TECHNICAL SERVICE BULLETIN

Illuminated MIL And/Or Powertrain Malfunction (Wrench) Indicator With Various Diagnostic Trouble Codes (DTCs)

26-2167

Ford 2022 e-Transit

Figure 1

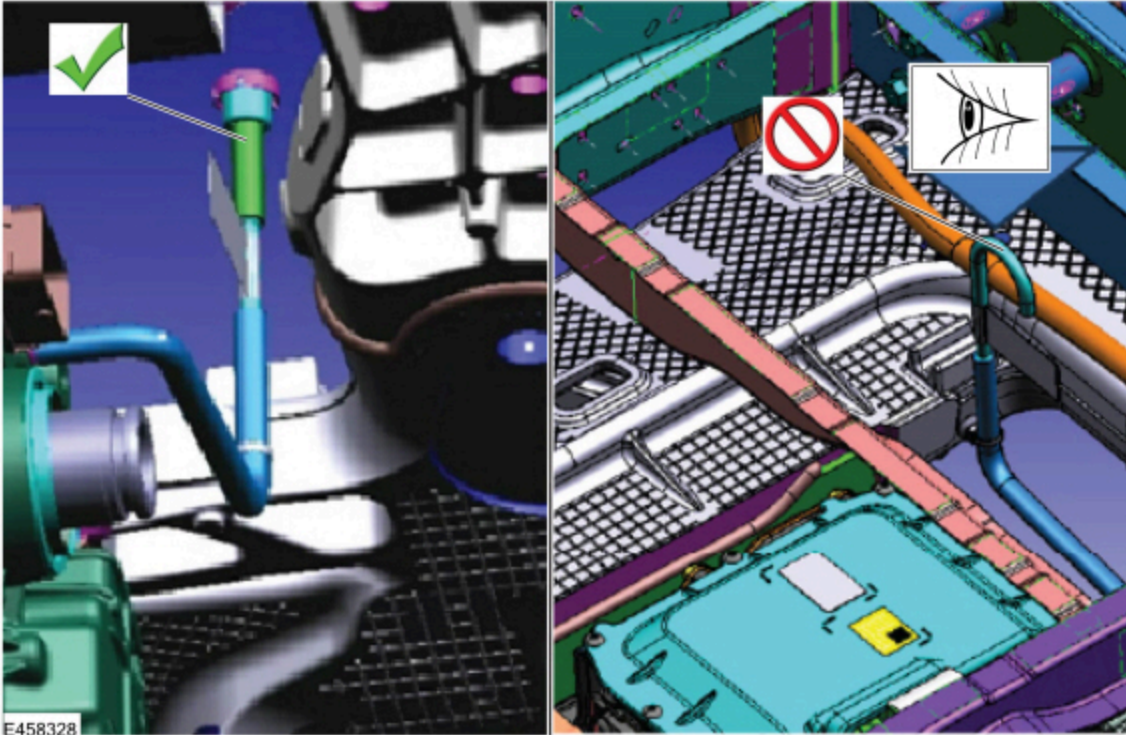
- Illuminated MIL and/or illuminated powertrain malfunction (wrench) indicator with DTCs P0711, P0A2B, P0A2D, P0A2C, P0712, P0713 and P1A10 stored in the SOBDMC.
- DTC P0AA6 stored in the BECM and/or IPC.
- Equipped with early design vent assembly attached to rear electric drive assembly. Refer to Figure 1.

2. Is the vehicle equipped with the rear electric drive assembly vent hose as shown in the image with the green check mark in Figure 1?

(1). Yes - proceed to Step 4.

(2). No - proceed to Step 3.

3. Remove and discard the rear electric drive assembly vent hose and replace with the updated part.
